Aurora Avenue Bible Church Plat 1 – Major Preliminary Plat

Request: Preliminary Plat Approval of a Major Subdivision Plat

MAJOR PRELIMINARY PLAT
**AURORA AVENUE BIBLE
 CHURCH PLAT I**
 45 NW AURORA AVENUE
 SHEET 1 OF 1

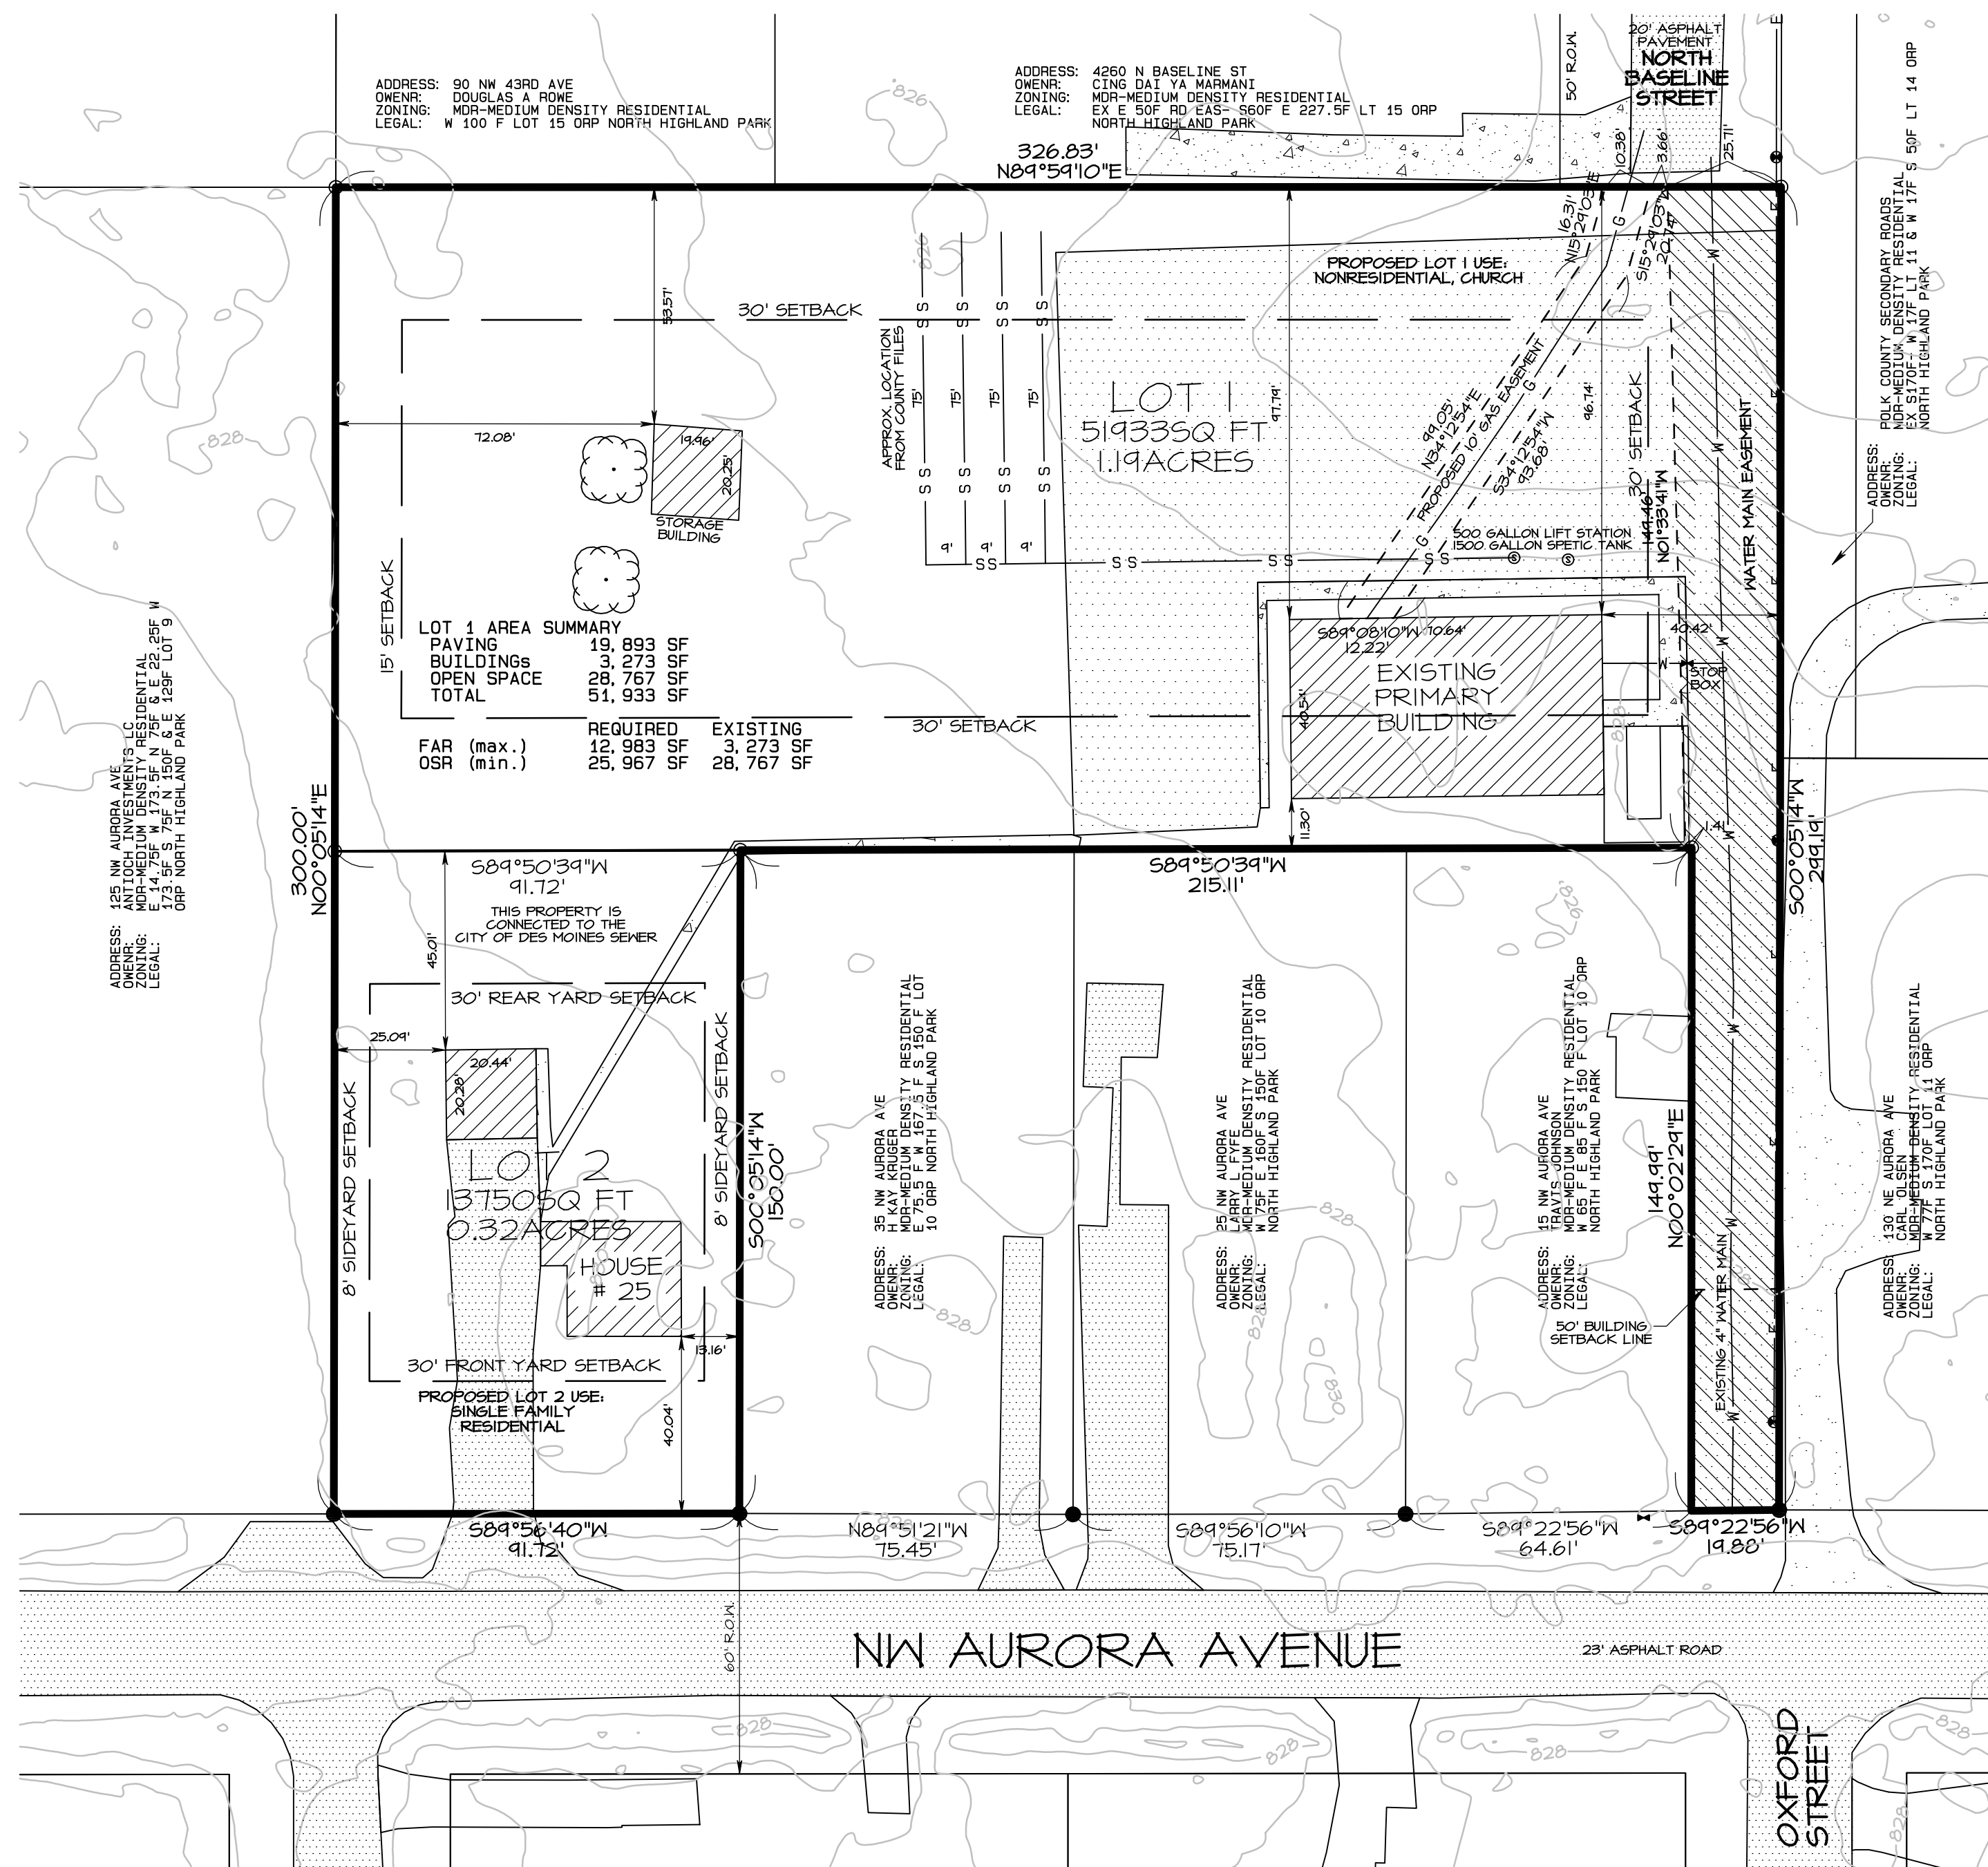
This preliminary plat (*Attachment 'B'*) is a reconfiguration of one (1) existing parcel creating one (1) single family residential lot with an existing single family dwelling and one (1) indoor institutional lot that contains an existing church and accessory structure on approximately 1.52 acres. Lot 2, the single-family residential lot, is proposed to be 0.32 acres (13,758 SF) and Lot 1, the indoor institutional lot, is proposed to be 1.19 acres. The subject property is entirely zoned “MDR” Medium Density Residential District. The ground adjacent to the north, east and west is zoned “MDR” with the east and north ground containing multiple parcels with single family dwellings and the west ground containing an apartment building. The ground adjacent to the south is within the City of Des Moines corporate limits and contains multiple single family dwellings. Lot 2 meets the Single-Family Bulk Standards for lot size, lot width, maximum building height, and maximum building coverage within the “MDR” Medium Density Residential district. Also, the existing single family dwelling on Lot 2 meets the 30-foot front and rear yard setbacks, and the eight (8) foot side yard setback requirement for properties located in the “MDR” Medium Density Residential District. Lot 1 is a conforming flag

lot configuration for non-residential lots. Non-Residential lots located within the “MDR” Medium Residential District require a 50-foot front yard setback and a 15-foot side and rear yard setback, plus an additional 15-foot peripheral setback for lots abutting a different development option. While the existing church on Lot 1 meets the required 50-foot front yard setback, 30-foot east side yard setback, and 15-foot west side yard setback, it is in a legal-nonconforming location as it encroaches into the 30-foot southern side yard setback. Lot 1 meets all Open Space (50%) and Floor Area Ratio (25%) requirements for properties in the “MDR” Medium Density Residential District. The two lots created with this subdivision have existing driveways that take access off of NW Aurora Avenue. Lot 1 also has a separate access to the north onto North Baseline Street that is currently fenced off to deter through traffic.

The subject property is flat throughout with a small elevation change from 828 feet in the southwest corner to 824 feet in the in the northeast corner of the property. The property contains a few existing mature trees that will not be affected by the proposed subdivision. The subject property does not contain any areas of mapped floodplain.

Water service is provided to the existing church on Lot 1 via a Des Moines Water Works (DMWW) four-inch (4”) water main that cuts through east side of the property along the church driveway. This water main will be placed in an easement according to Des Moines Water Works (DMWW) specifications. Des Moines Water Works (DMWW) also serves the existing single family dwelling on Lot 2 via a four-inch (4”) water main on the south side of NW Aurora Avenue. Lot 1 is served by an on-site wastewater treatment system with a septic field located west of the existing parking area while the existing dwelling on Lot 2 is connected to the City of Des Moines sewer system. There is a proposed 10-foot gas easement for a gas line that connects the existing church to a gas main on the west side of North Baseline Street. No new roadway improvements are proposed with the current configuration of this subdivision, as both lots would retain their existing access onto NW Aurora Avenue.

Staff has reviewed this plat for compliance with the Polk County Zoning and Subdivision Ordinances as a major subdivision plat submittal. The plat is considered a major subdivision because the proposed lots represent another lot created after there has already been 5 lots created in the larger aliquot part (the Southwest ¼ of the Northwest ¼ of Section 23, Saylor Township). Lot density, dimensions, frontage, and access have been reviewed, and meet all Polk County Zoning and Subdivision Requirements. Following the Zoning Commission’s recommendation, and addressing remaining staff comments, the applicants may forward the preliminary plat and recommendation to the Board of Supervisors for their consideration and approval. If approved by the Board of Supervisors a final plat and required legal documents may be prepared and submitted for the County’s review, final approval and recording. At this stage, the Commission’s recommendation would affirm, deny, or amend the overall plat layout.

The property lies within the two-mile review jurisdiction of Des Moines. The City of Des Moines has been notified of the request and will complete a full review of the proposed subdivision. Certified resolution from the City of Des Moines, either approving or waiving their review authority, shall be provided at the time of final plat and recording.

Staff recommends approval of the Preliminary Plat of Aurora Avenue Bible Church Plat 1.
